**Cross Alameda Trail  
Ralph Appezzato Memorial Parkway Improvements**

**PROJECT NUMBER P.W. 03-18-11**

**ADDENDUM NO. 05**

**Addendum No. 05** is hereby issued in response to the following Bidders’ Questions, responses for which are hereby incorporated into the Bidding Documents:

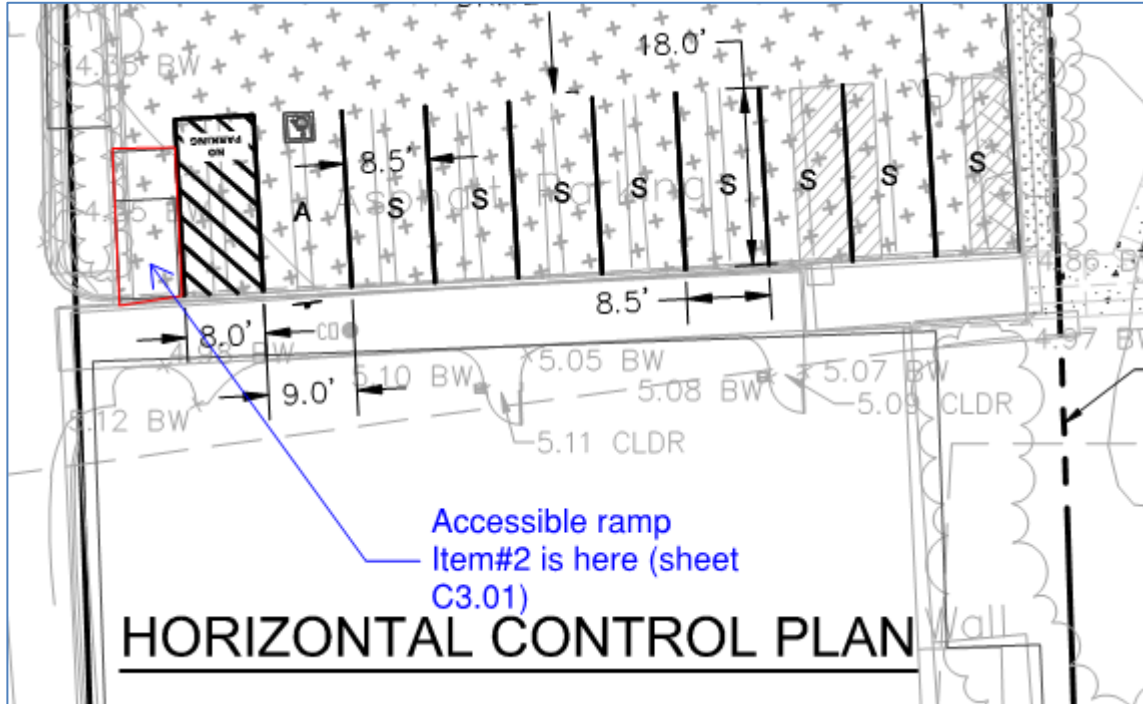
- 2) **Question:** Sectional view A/C2.02 shows a bus stop and asphalt bicycle path on sheet C3.11. However the sheet does not show asphalt hatching from the legend on the path nor does it show a bus stop. Please clarify?
